State of New Mexico
 Energy, Minerals and Natural Resources

OXY USA WTP LP. respectfully requests approval to P&A the subject well. The proposed plugging plan, current wellbore diagram and proposed wellbore diagram are attached.

INDIAN BASIN 32 STATE #06

P&A PROCEDURE

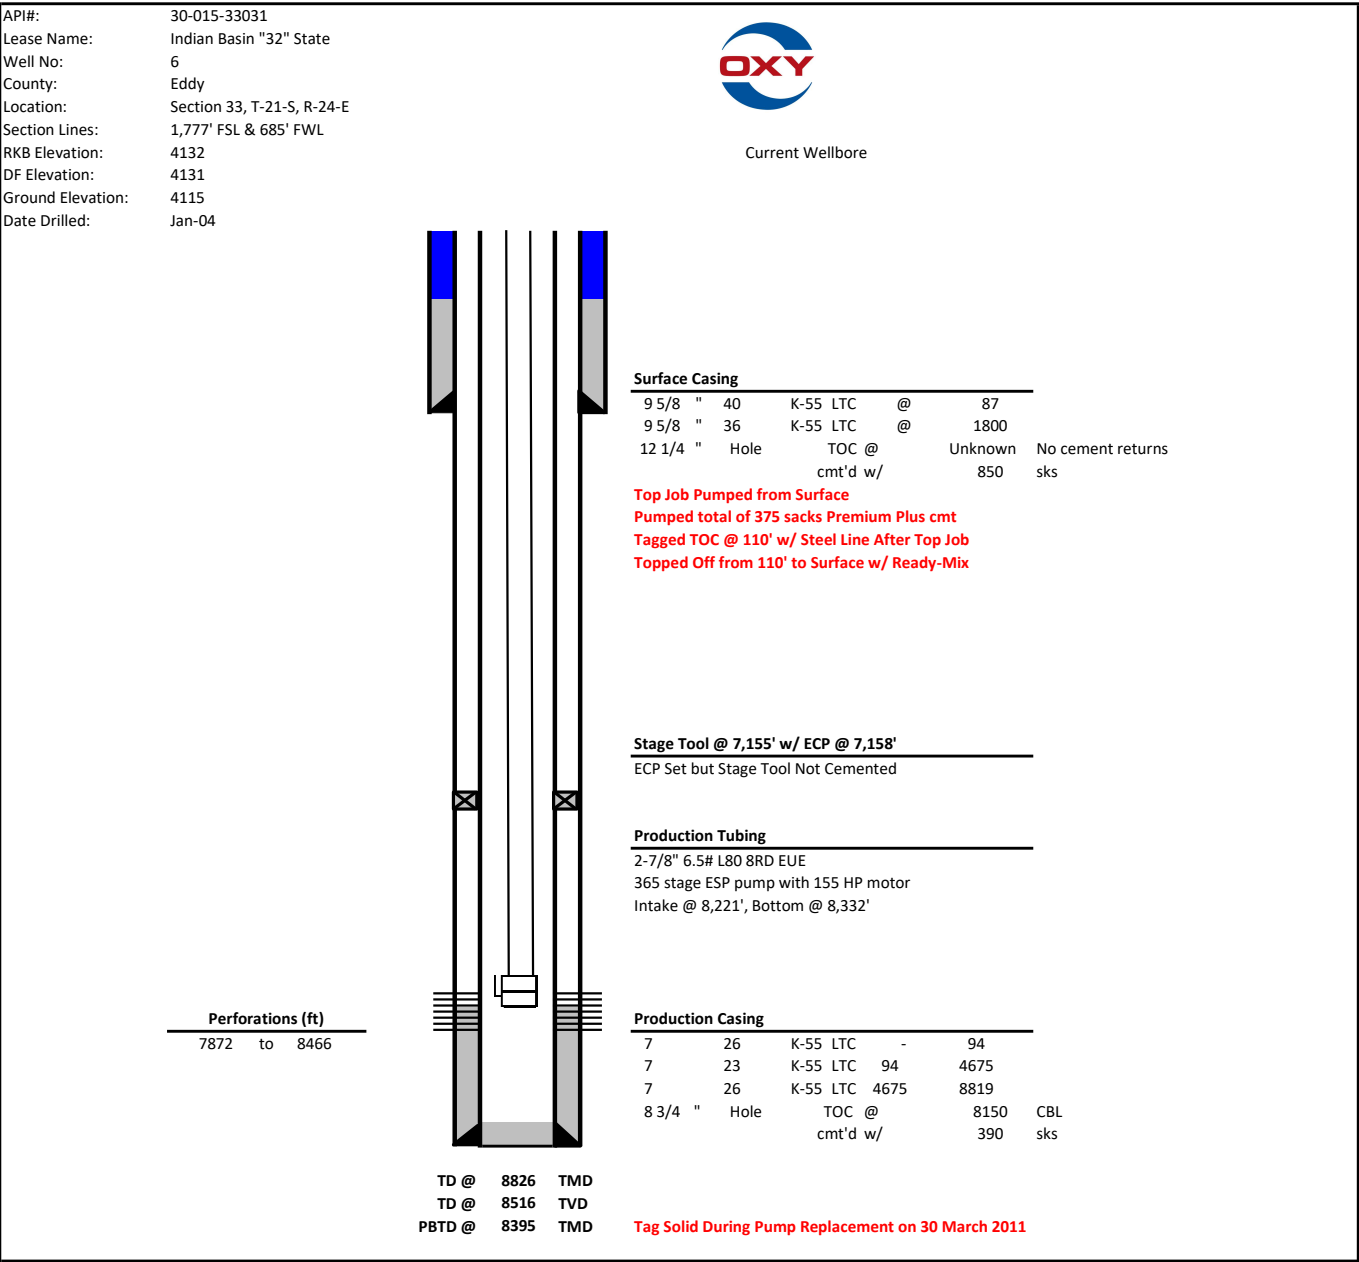
10# MLF BETWEEN PLUGS. UTILIZE ABOVE STEEL GROUND TANKS.

1. SET CEMENT RETAINER AT 7822'. SQUEEZE THROUGH RETAINER W/ 105 SX CLASS H CMT.
2. STING OUT OF RETAINER AND SPOT **30** SX CLASS H CMT 7822'-7686'. WOC AND TAG.
3. **Test Casing and plug 500psi/30min - Bubble test-** RUN CBL 7650'-SURFACE.
4. PERF AT 7438'. SQZ W/ 55 SX CLASS H CMT 7438'-7338'. WOC AND TAG.
5. PERF AT 7205'. SQZ W/ 55 SX CLASS H CMT 7205'-7105'. WOC AND TAG.
6. **Spot 25 sx cmt 4150' - 4000'**
7. PERF AT 3864'. SQZ W/ 55 SX CLASS C CMT 3864'-3764'. WOC AND TAG.
8. **Perf @ 2953' Sqz 55 sx cmt 2953' - 2853' - Yeso**
9. PERF AT 2729'. SQZ W/ 55 SX CLASS C CMT 2729'-2629'. WOC AND TAG.
10. PERF AT 1850'. SQZ W/ 55 SX CLASS C CMT 1850'-1750'. WOC AND TAG.
11. PERF AT 1161'. SQZ W/ 55 SX CLASS C CMT 1161'-1061'. WOC AND TAG.
12. PERF AT 430'. CIRCULATE 220 SX CLASS C CMT 430'-SURF. WOC AND VERIFY CMT AT SURF.
